STAFF REPORT: PERMIT AMENDMENT

APPLICATION NO.: **A-1-MEN-01-056-A1**

APPLICANT: **Steve and Lisa MacCubbin**

DESCRIPTION OF AMENDMENT REQUEST: **Modify the design of the approved house resulting in a reduction of floor area of 611 square feet, a reduction of the roof height of the residence by two feet, a substantial reduction in the bulk of the roof structure, and minor door and window changes and**

EXHIBIT NO. 4
APPLICATION NO.
A-1-MEN-01-056-A1
(MacCubbin) PROPOSED
AMENDED PROJECT PLANS
(Page 1 of 7)

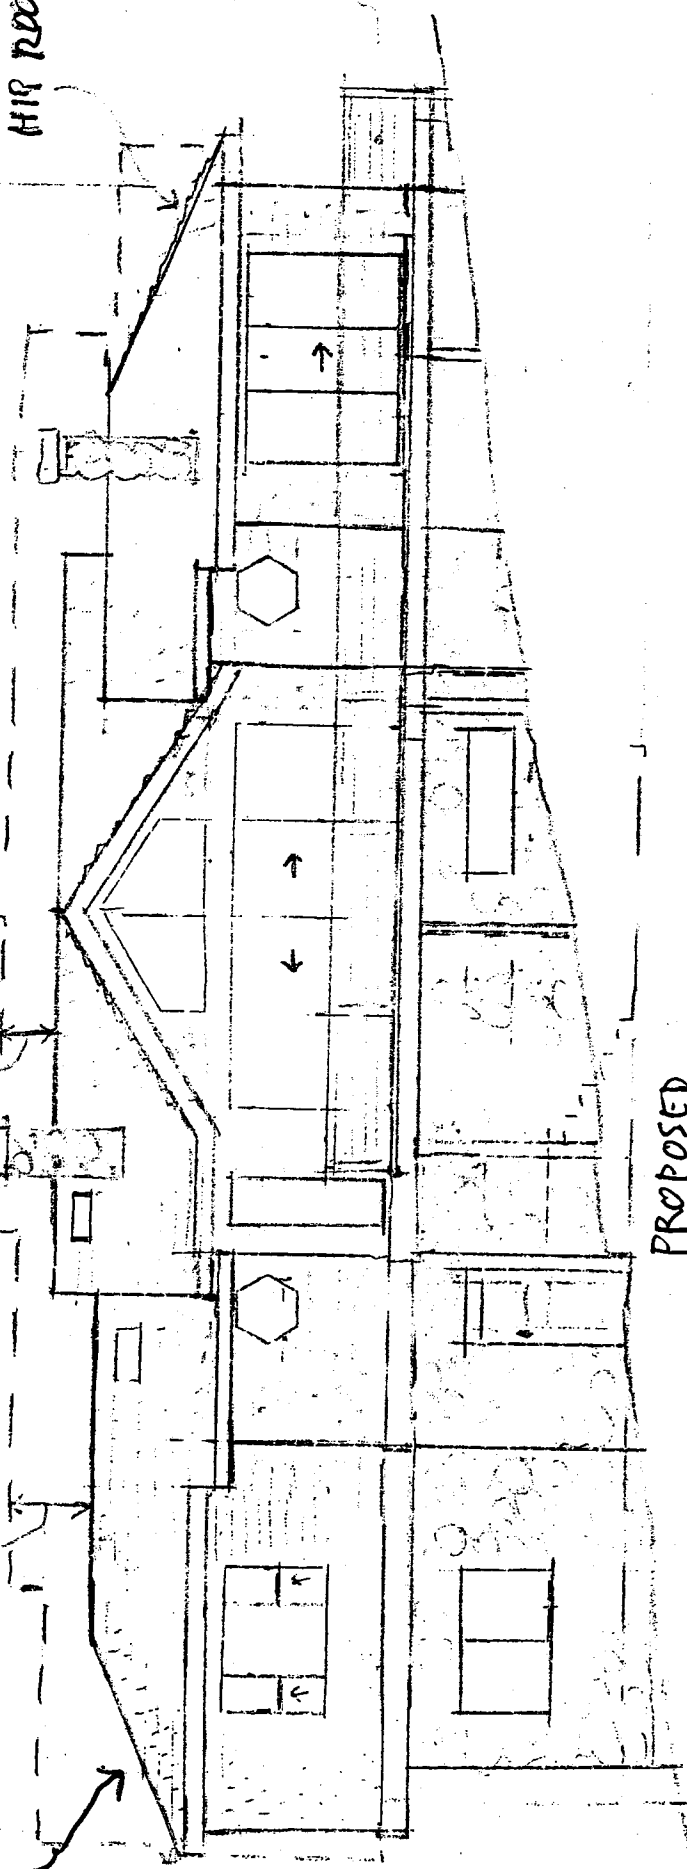
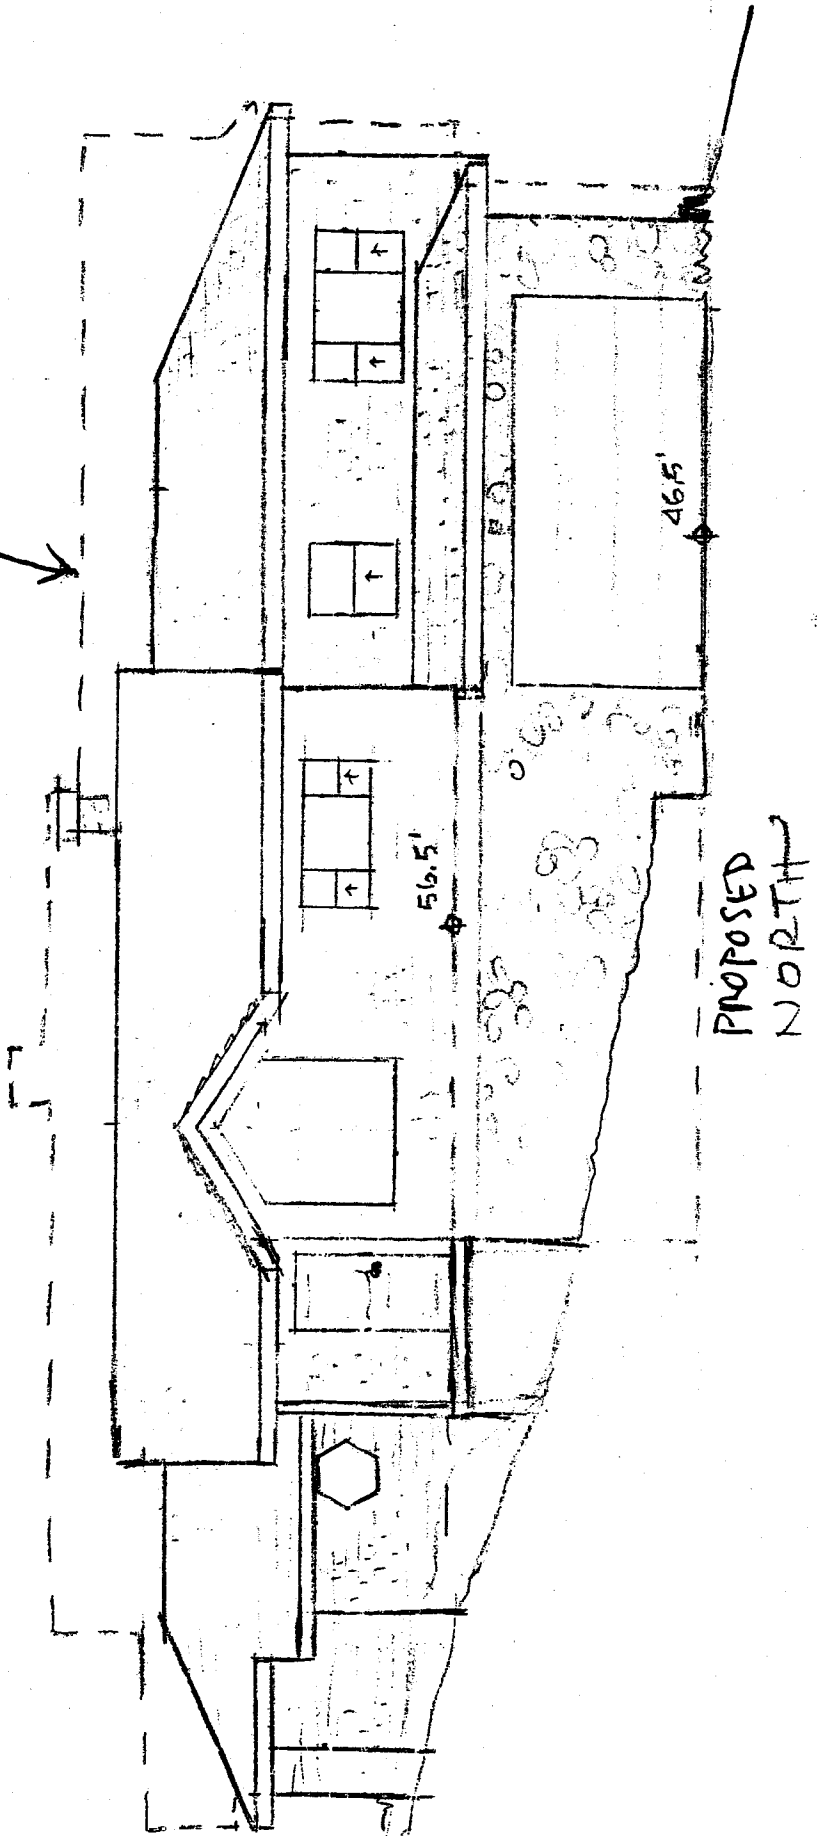
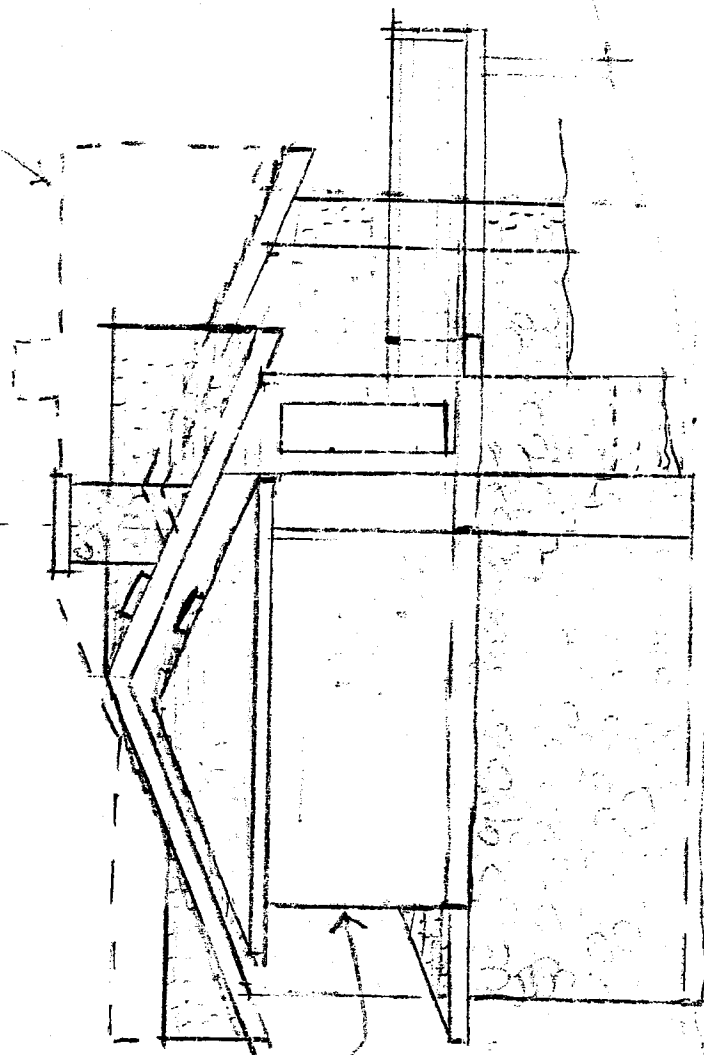
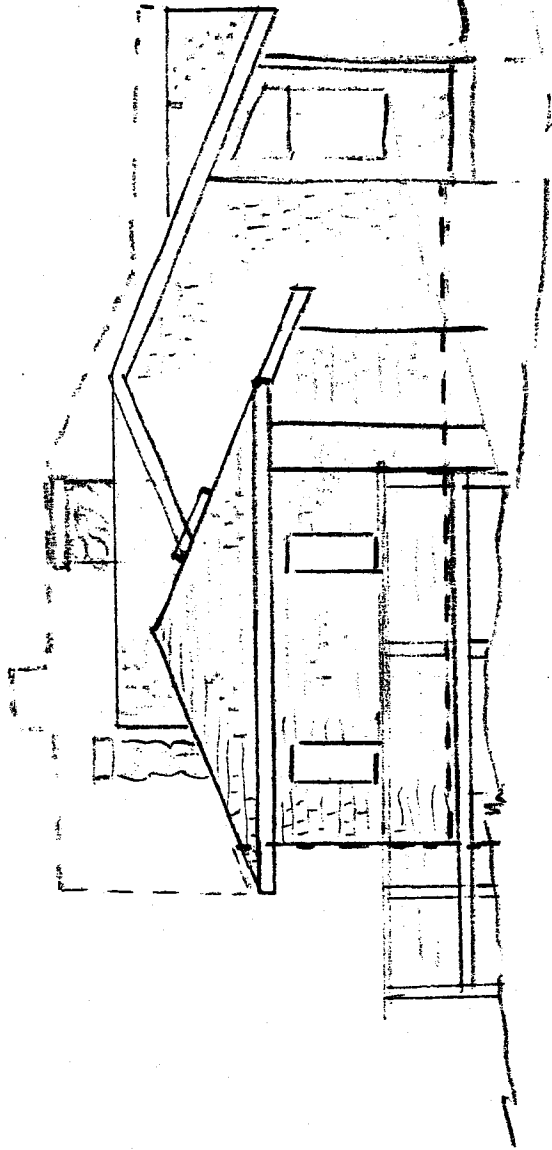
69' AS APPROVED

68' PROPOSED CHANGE

2'-6" REDUCTION

2' REDUCTION

OUTLINE OF
APPROVED HOUSE
SHOWN DOTTED

REDUCE SIZE
OF GABLE

UPPER FLOOR WALL
SETBACK OVER
GARAGE
